# Access Compliance Report

## Public Rights-of-Way

Intersection ID: 9402	Main Street: TERRA_COTTA_DR	Cross Street: VERMILION_DR	Location: NW
ADA ID: 049996881F98	Ramp Type: Perp	Initial Pass/Fail: Fail	Overall Compliance: No
Severity Score: 13.75			
Codes/Mitigation Info/Possible Solution		Field Measurements/Component Compliance

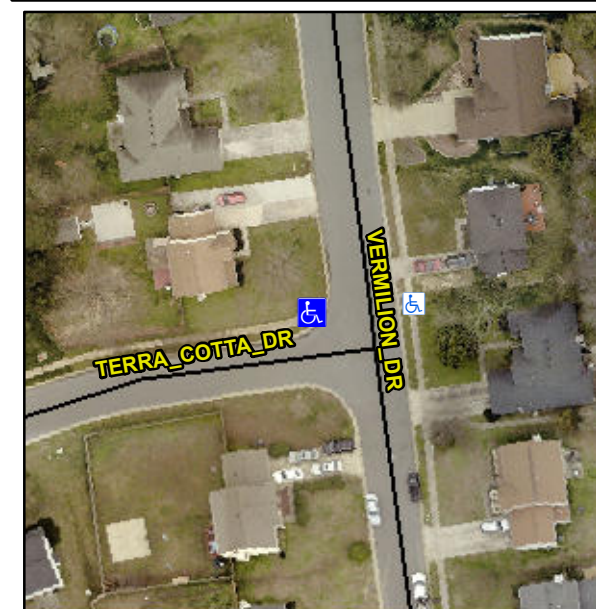
**Not Found, R304.2.2, R304.5.3**

Compliance	Description	Data	Compliance	Description	Data
N/A	Ramp Length (in)	49.5	No	Ramp Slope (%)	9.9
Yes	Ramp Width (in)	48.0	No	Ramp XSlope (%)	2.5
N/A	Flare Type LT	N/A	N/A	Flare Type RT	N/A
N/A	Flare Slope LT (%)	N/A	N/A	Flare Slope RT (%)	N/A
N/A	Flare Traversable LT?	N/A	N/A	Flare Traversable RT?	N/A
N/A	Landing Length (in)	N/A	N/A	DWS Provided?	N/A
N/A	Landing Width (in)	N/A	N/A	DWS Contrast?	N/A
N/A	Landing Slope (%)	N/A	N/A	DWS Length (in)	N/A
N/A	Landing X Slope (%)	N/A	N/A	DWS Full Width?	N/A
N/A	Landing Curb? (Y/N)	N/A	N/A	DWS Offset (in)	N/A
N/A	Shared Landing?	N/A			
N/A	Gutter Ponding?	N/A	N/A	Gutter Slope (%)	N/A
N/A	Gutter Lip Ht (in)	N/A	N/A	Gutter X Slope (%)	N/A
N/A	Painted X Walk1?	No	N/A	Painted X Walk2?	N/A
	X Walk 1 Direction	To E		X Walk 2 Direction	N/A
N/A	X Walk 1 Width (in)	N/A	N/A	X Walk 2 Width (in)	N/A
	X Walk 1 Slope (%)	2.7		X Walk 2 Slope (%)	N/A
	X Walk 1 X Slope (%)	0.7		X Walk 2 X Slope (%)	N/A

**Remove & Replace Entire Ramp.**
